CAR17-00003, PUD17-00005 & SUB17-00012 / A Team Land Consultants

Planning Division Project Report

File Numbers	CAR17-00003, PUD17-00005 & SUB17-00012
Applicant	Steve Arnold / A Team Land Consultants
Property Address	3091 N Maple Grove Rd
Public Hearing Date	April 3, 2017
Heard by	Planning and Zoning Commission
Analyst	Céline Acord, Associate Planner
Reviewed by	Cody Riddle, Current Planning Manager

Project/File: **Knob Hill Subdivision/ BPP17-0004/ SUB17-00012/PUD17-00005/CAR17-00003**
The applicant is requesting approval of a preliminary plat, planned unit development, and a rezone for Knob Hill Subdivision. The proposed subdivision consists of 4-buildable lots on 0.94 acres located at 3091 N. Maple Grove Road.

PRELIMINARY PLAT/PUD MAP KNOB HILL
BEING A PORTION OF LOT 7 AND 8, BLOCK 4 OF HOME ACRES No. 18, AS SHOWN IN IN BK. 11 OF PLATS PG. No.633 LOCATED IN NE 1/4 NE 1/4 OF SEC. 2, T.3 N., R.1E., CITY OF BOISE B.M. ADA COUNTY, ID.

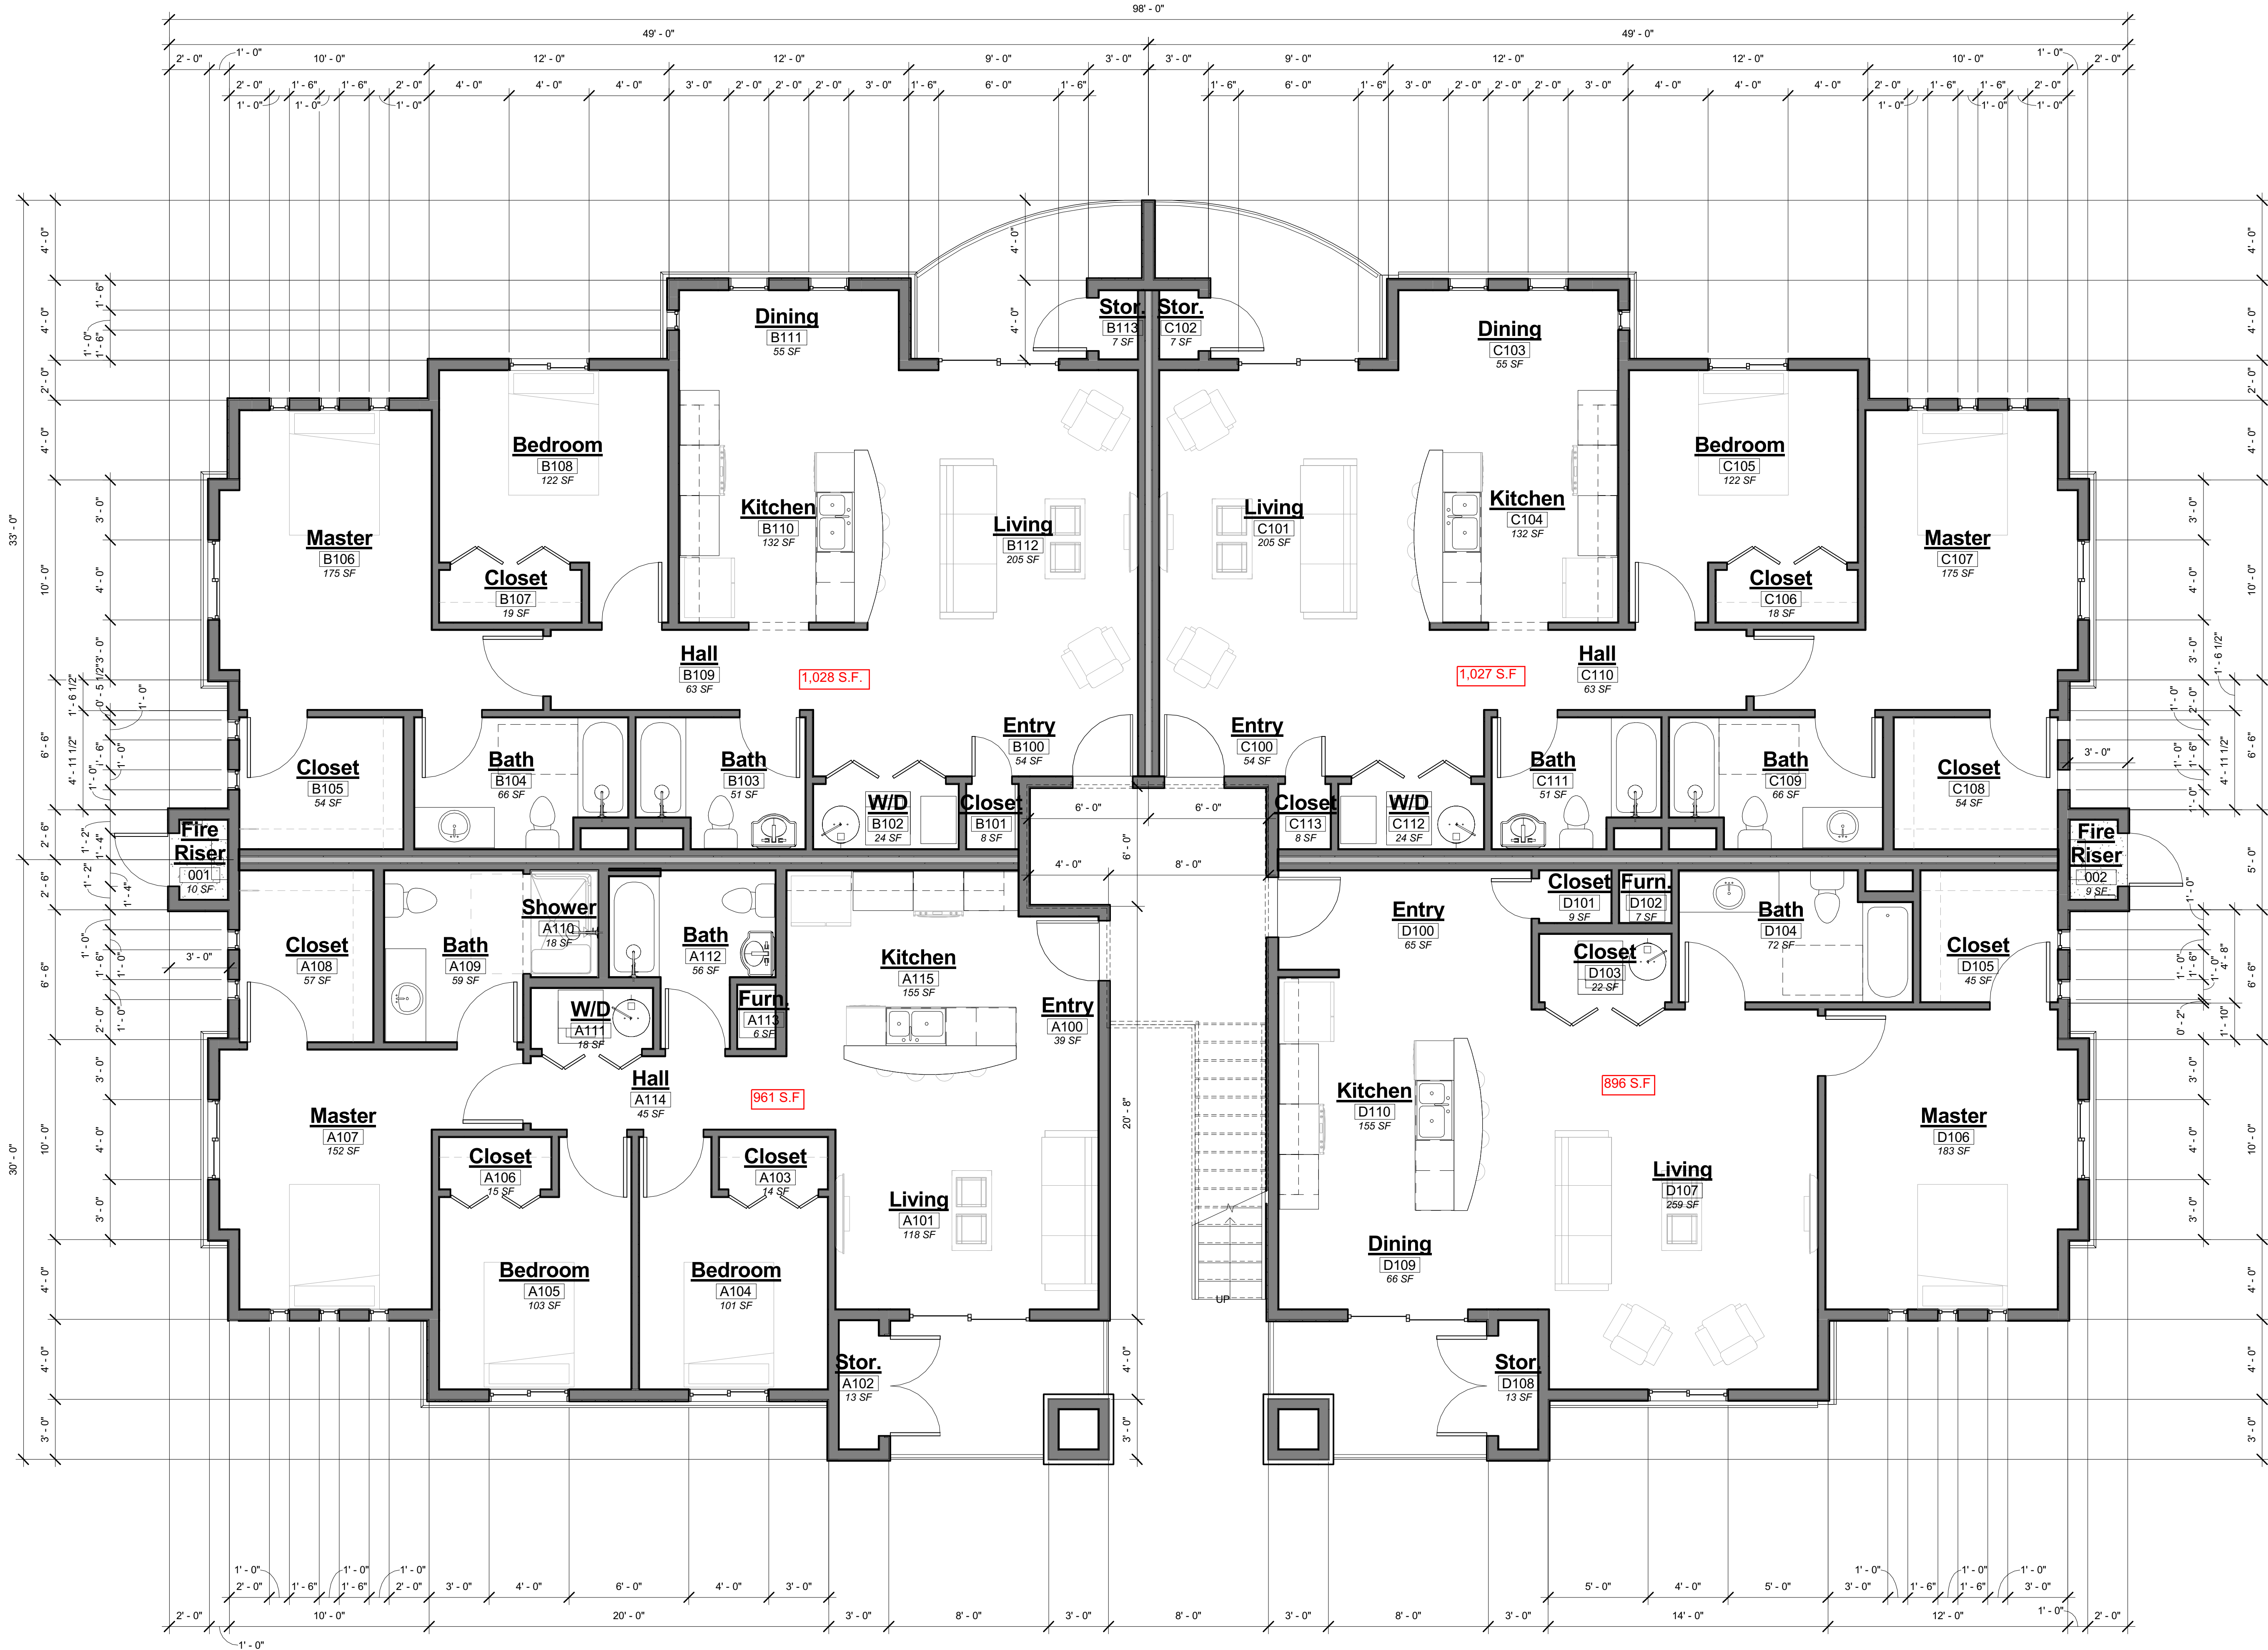
** Two bicycle racks are shown on the submitted plans. They do not meet the standards of *BCC 11-07-03.3(B)*. A recommended condition of approval will require a minimum of 16 bicycle spaces in compliance with the Code.

2. **Planned Unit Development**
 - a. The storage buildings along Maple Grove Rd shall comply with the front setback of 20 feet.
 - b. The residential structures may have a reduced internal side yard setback of zero feet and shall comply with the Multi-Family Standard (*BCC 11-06-03.2*) perimeter setbacks of 15 feet.

SITE PLAN

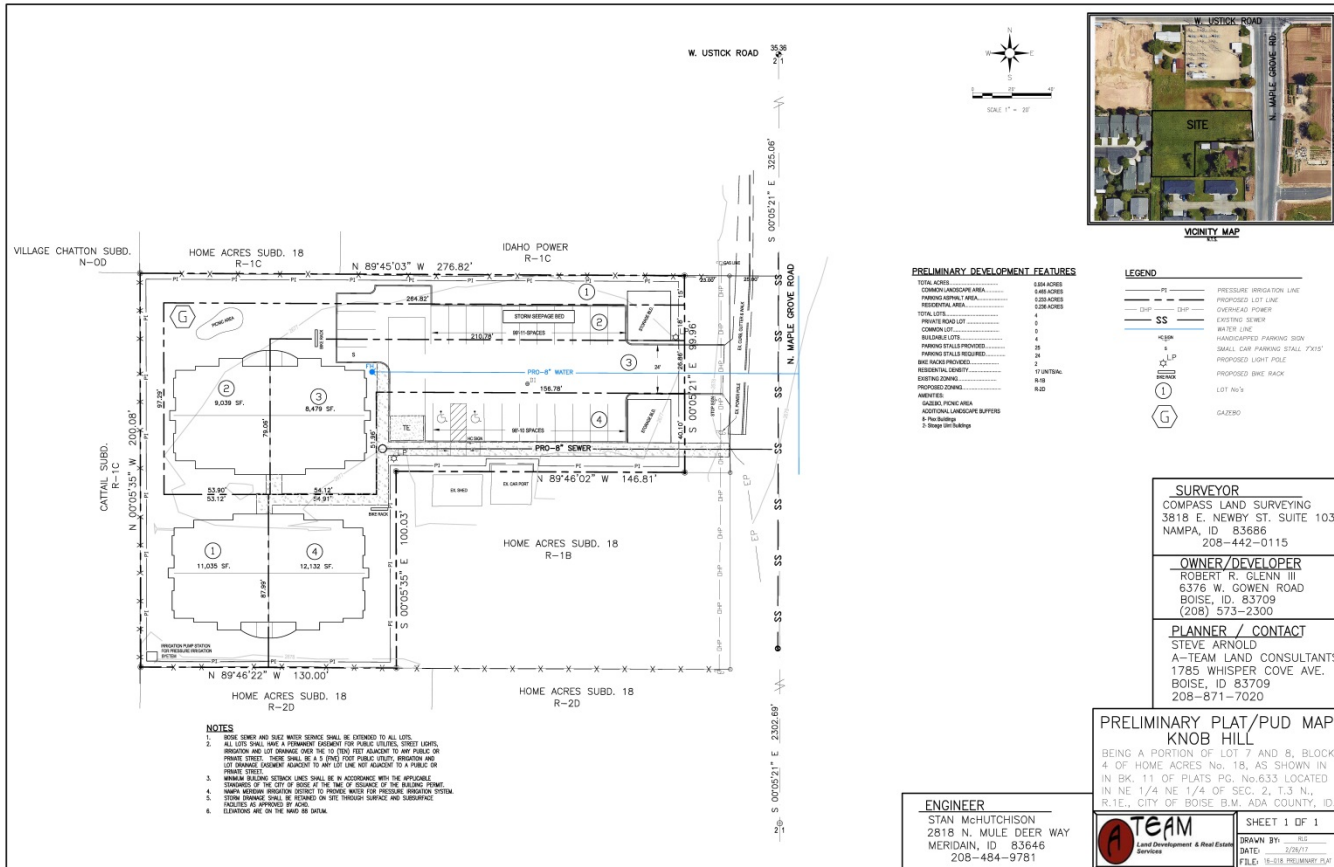
street, cross access with adjacent parcels is not available, and there is not enough frontage to meet the minimum separation standards. Therefore, staff recommends a modification of policy to allow the driveway to be located as proposed, as a temporary full access driveway that may be restricted to right-in/right-out in the future. The driveway may be relocated and/or restricted if the land use intensifies, changes, or the property redevelops or as necessary for safety and traffic operation needs as determined by ACHD.
